# Service Bulletin

NO. 338

### FRONT SEAT CUSHION SPRING MODIFICATION AND RELOCATION OF COVER TO ELIMINATE CUSHION COVER DAMAGE - 1958 2-DOOR MODELS

Fig. 1

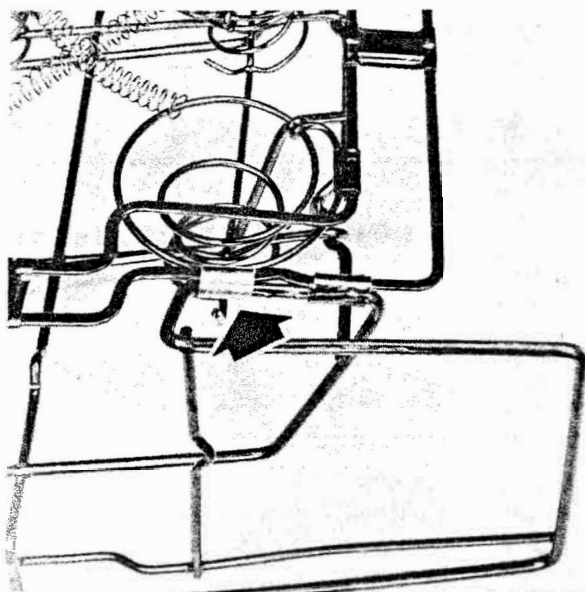
The installation of a second clip (see Fig. 1) on each side of the cushion spring assembly and relocation of the cushion padding as shown in Fig. 2 will eliminate the possibility of cushion cover damage in the clip area. This change entered production with the following serial numbers:

When the clip loosens, the spring assembly top rim and skirt wires separate and cause additional pressure on the cushion cover which may result in damage. Should evidence of this condition appear, on the vehicles manufactured prior to the above serial numbers, immediate action should be taken to fabricate and install a second clip and relocate the padding as described.

The clip may be made from a piece of stock .045" - .050" thick, 5/8" wide and 1 1/2" long.

Place the flat side of the top rim wire directly on top of the skirt wire as shown on Fig. 1 then install the fabricated clip securely.

Fig. 3

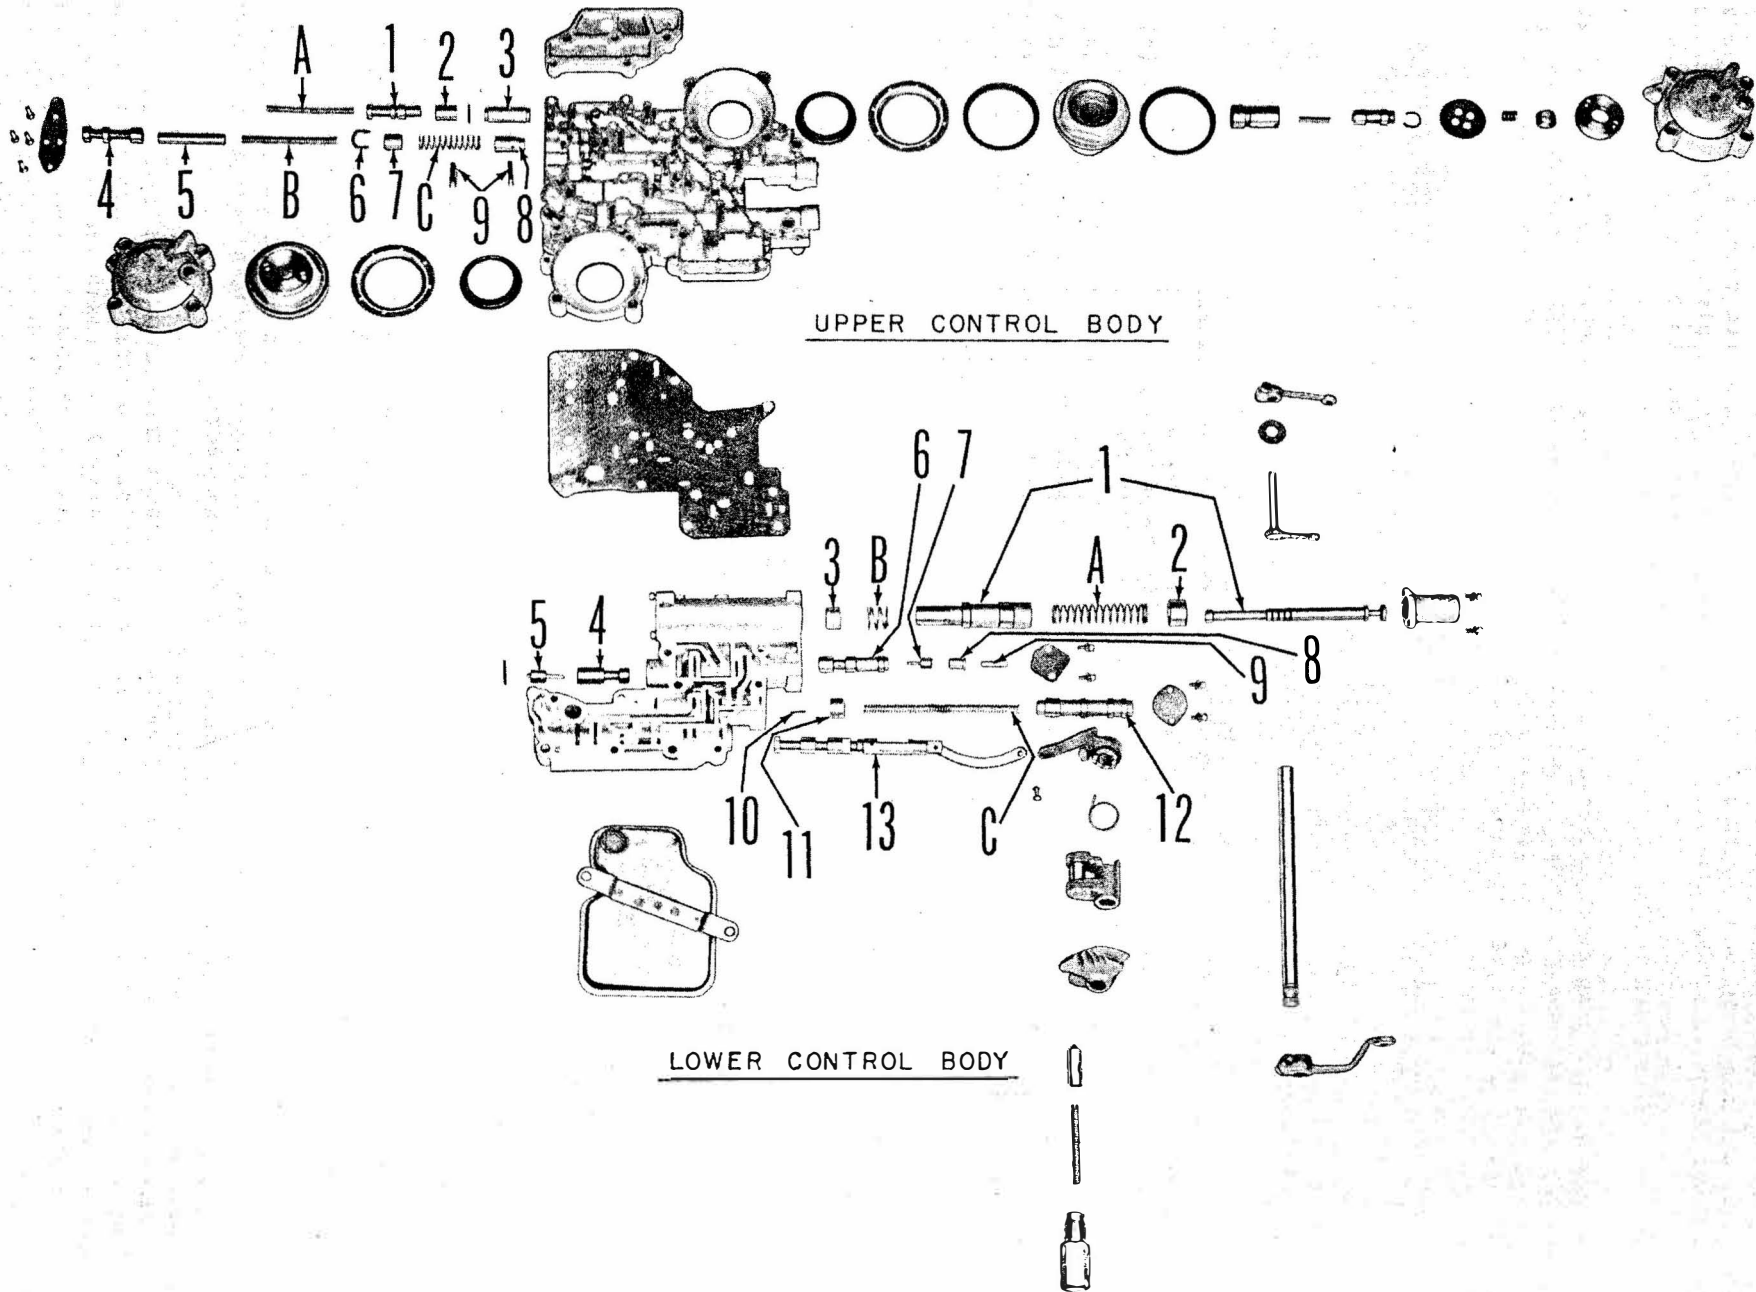
The Valve Control Assembly illustrated in Fig. 3 is Part No. 423800 and is the standard control unit as used in the 1954 Ultramatic prior to gear start. It is supplied for service as a complete assembly replacement for all Ultramatic Transmissions of the 23rd Series after transmission No. 101509, Model 2301 and transmission No. 5360, Models 2302-06, and all 24th Series through the 54th.

During the production of the 1952-25th series cars the converter relief valve was discontinued. The valve, valve spring and spacer were replaced by Converter Relief Plug, Part No. 423548. This may be applied to the 24th and early 25th series that still have the valve, spring and spacer.

The Throttle Shaft and Valve Assembly Part No. 423779 applies to the 1954 Ultramatic prior to gear start and Assembly Part No. 423115 applies to 24, 25 and 26th series.

Assembly Part No. 423779 also has an additional coast spring which was not used in preceding models.

When assembling the upper and lower valve bodies and separator plate, torque tighten the cap screws evenly to 5 foot pounds (1/4-20 screws).

When securing the valve control body assembly to the transmission case tighten the cap screws evenly to 9 foot pounds torque (5/16 - 18 screws).
